Case Name/ Number: A Better Place Conditional Use Permit / RCU2022-00018

RE: RCU2022-00018 A Better Place Conditional Use Permit

COMMENT RESPONSE LETTER: ADAMS COUNTY A BETTER PLACE – CONDITIONAL USE PERMIT

A BETTER PLACE
 7261 WASHINGTON STREET, DENVER, CO 80229
 CONDITIONAL USE - SITE PLAN

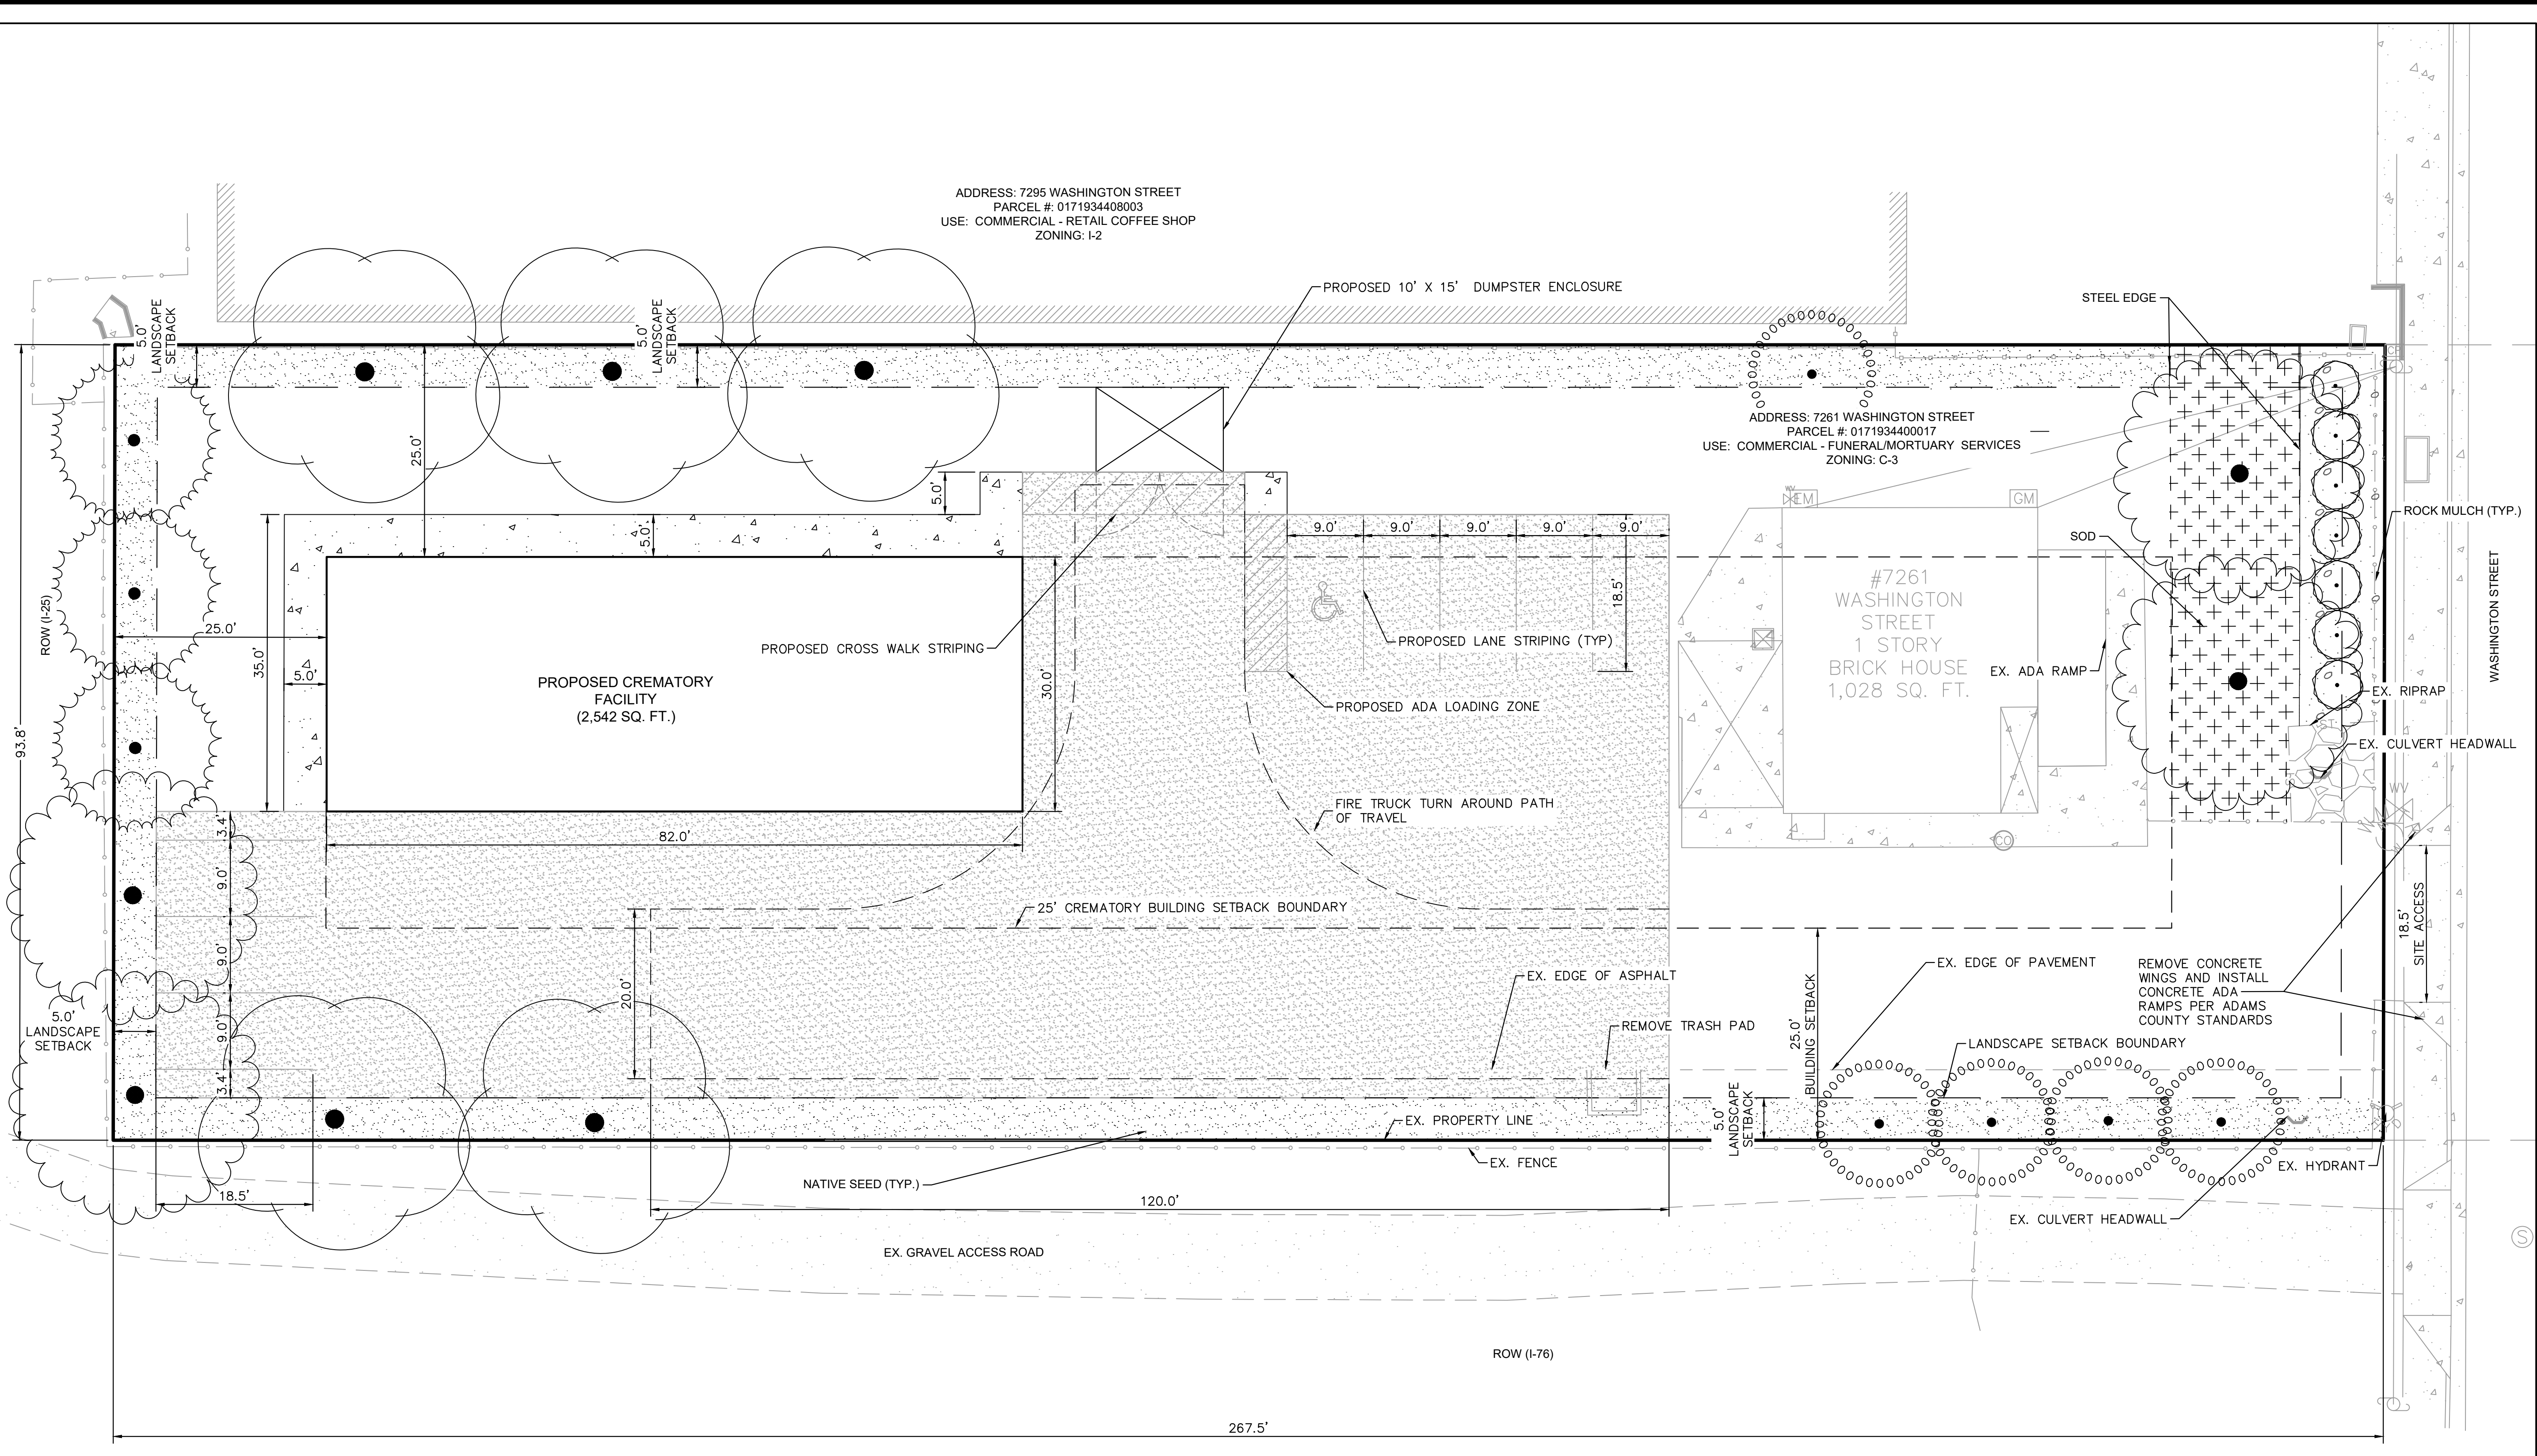
1. PLN01: Please provide the following information in a revised site plan:
 1. width of the site in your revised site plan.
 2. Setback for the dwelling at the front of the property.
 3. Northern setback of the proposed crematory from property line
 - *Response: The following information is provided in a revised site plan.*

3. PLN03: The current site plan proposes 4 parking spaces and 1 ADA compliant parking space. Will additional parking be required as part of the crematorium use? Will the proposed structure have a loading zone? If so, please include the location in a revised site plan.
 - *Response: 6 standard and 1 ADA stall is being proposed, and the proposed structure has loading zones inside the crematorium located at the pull in entrances shown on the site plan.*

5. PLN05: The current location of the trash enclosure could lead to unforeseen accidents. A more suitable are for the enclosure would be in the rear of the property and away from constant traffic of the site.

- *Response: The trash enclosure relocated to the north side of the site and is out of the way but still accessible. No longer adjacent to constant traffic.*
- 6. PLN06: Please provide elevations for the proposed crematorium and trash enclosure to review compliance with Height of structure.
 - *Response: Elevations for proposed crematorium and trash enclosure are provided.*
- 7. PLN07: Please review all comments by County Staff and outside agencies as well as citizen comment regarding your proposed project and address them accordingly.
 - *Response: All comments are reviewed and addressed accordingly in this letter.*

A BETTER PLACE
7261 WASHINGTON STREET, DENVER, CO 80229
LANDSCAPE PLAN

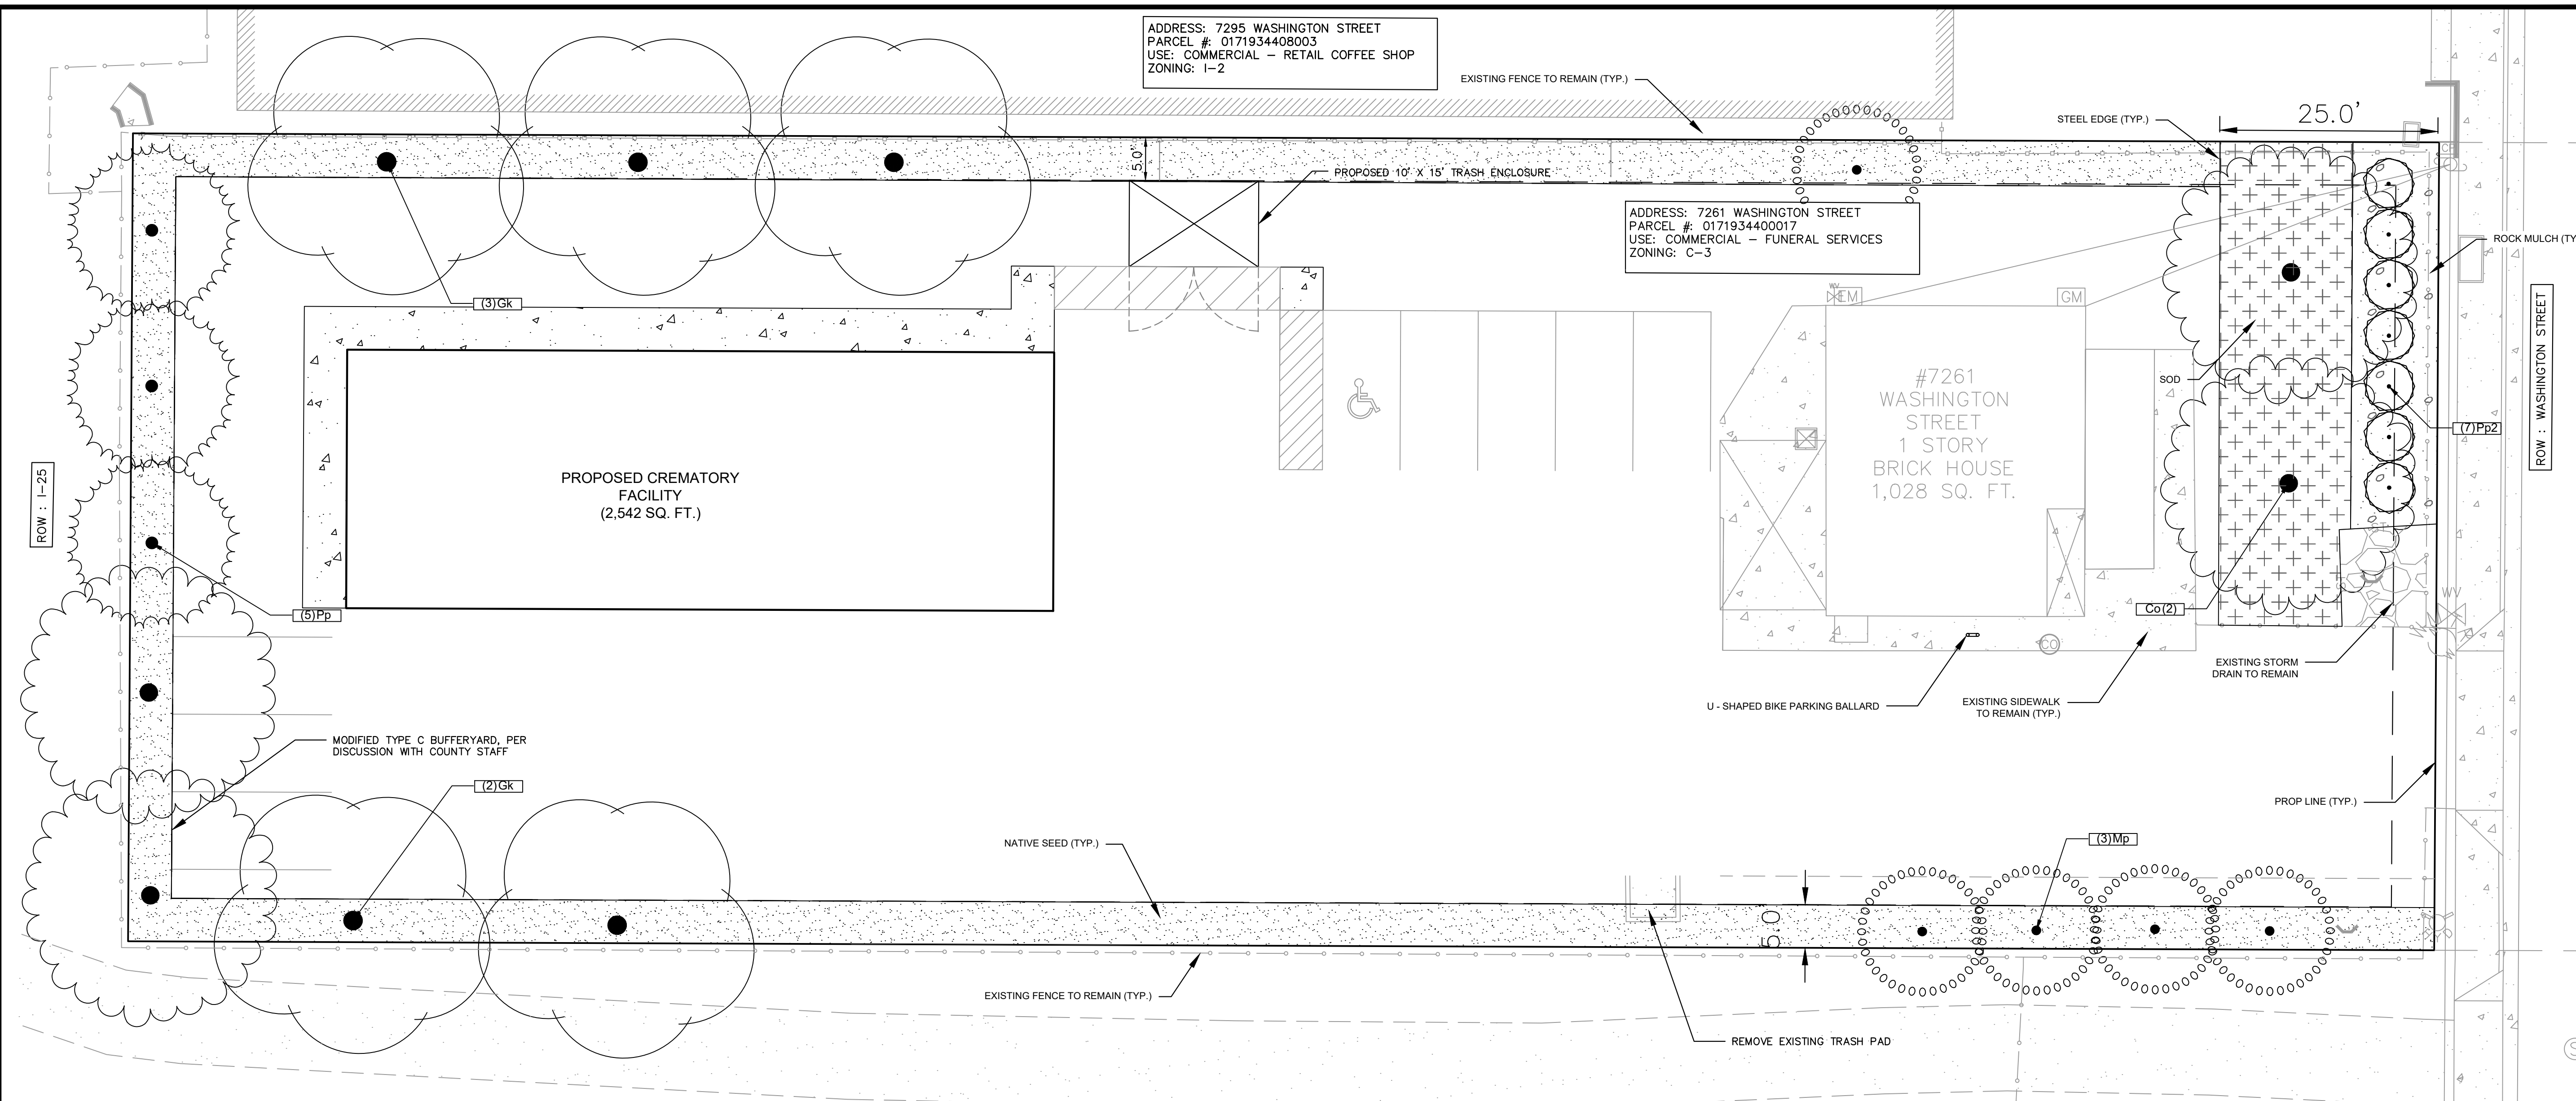
4. PLN04: Please include the landscape that was approved for this site as part of permit BDP22-1125.
 - *Response: Approved landscaping has included on the site plan.*
